# UNITED STATES PATENT AND TRADEMARK OFFICE

APPLICATION NO.	FILING DATE	FIRST NAMED INVENTOR	ATTORNEY DOCKET NO.	CONFIRMATION NO.
10/573,618	03/27/2006	Hartmut Nitzsche	101914450	9019

## Office Action Summary

## **DETAILED ACTION**

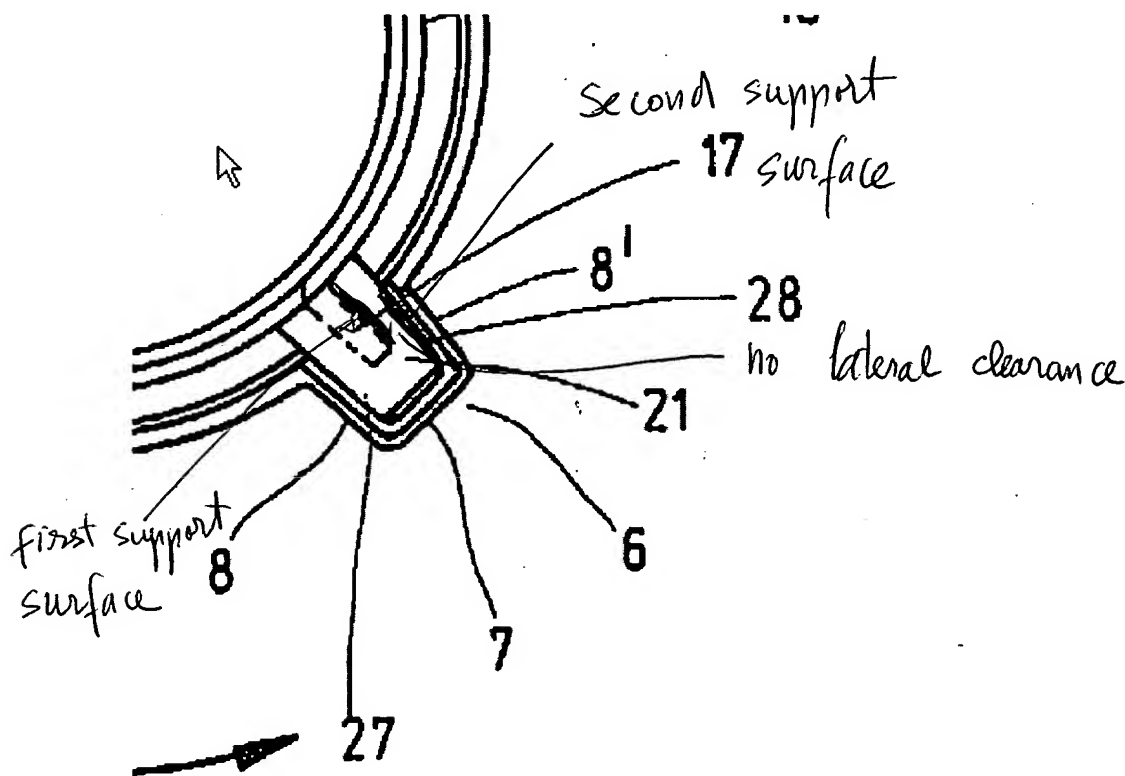
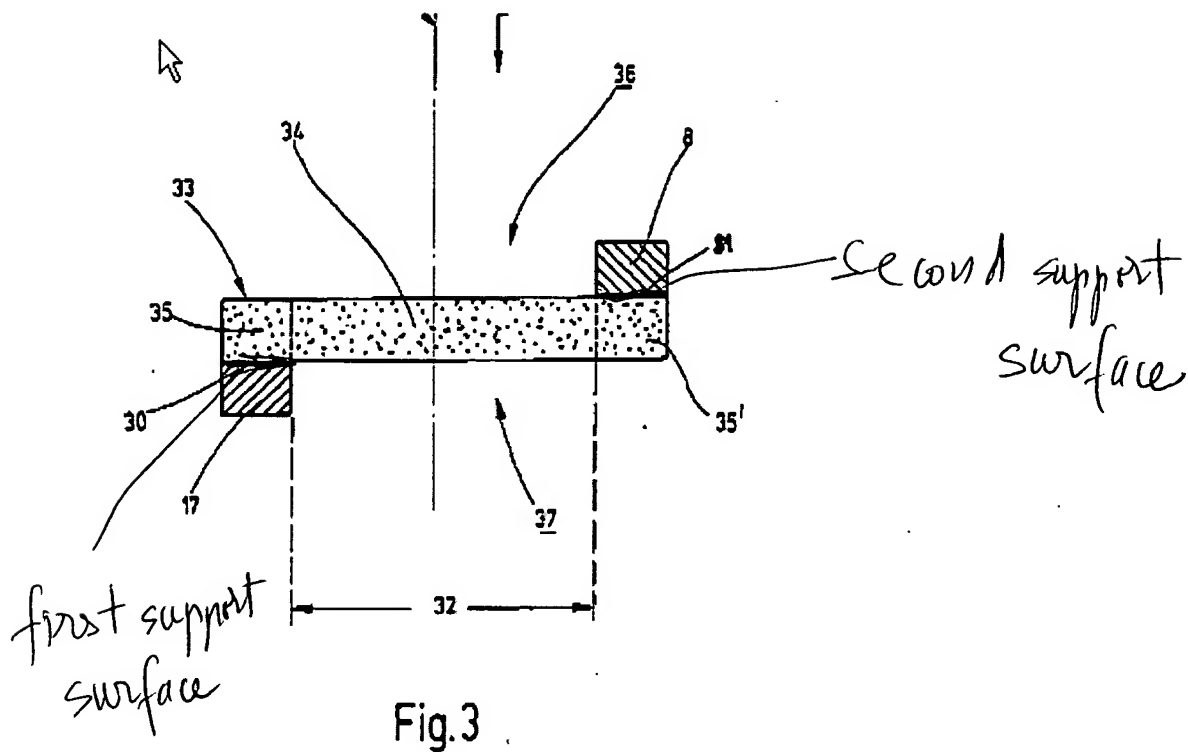
Regarding claim 17, the limitation "the at least one first support surface and the at least one second support surface have a lateral clearance from each other" and "the at least one first elastic element bridges the lateral clearance in the form of a first free bridge" is not understood by an ordinary skill in the art.

Figures 1, 2 show holding tab 17 formed on the stator frame of motor 12. Holding tab 17 is covered on two sides by damping element 21 as shown in Fig. 1. The side wall 28 of damping element 21 is between holding tab 17 and pocket side wall 8'. As best understood by the Examiner and shown in Fig. 3, the first support surface 30 is the surface of the overlapping region of the holding tab 17 and elastic member and the second support surface 31 is the overlapping region of the pocket side wall 8' and the elastic member. However, as shown in Fig. 2, there is no lateral clearance between first support surface 30 and the at least one second support surface 31 and the disclosure does not show how the lateral clearance 32 is formed in Fig. 3. Fig. 4 shows an embodiment quite different from Fig. 2 with two holding tabs 17 on one side of the elastic member and pocket side wall 8' on the other side.
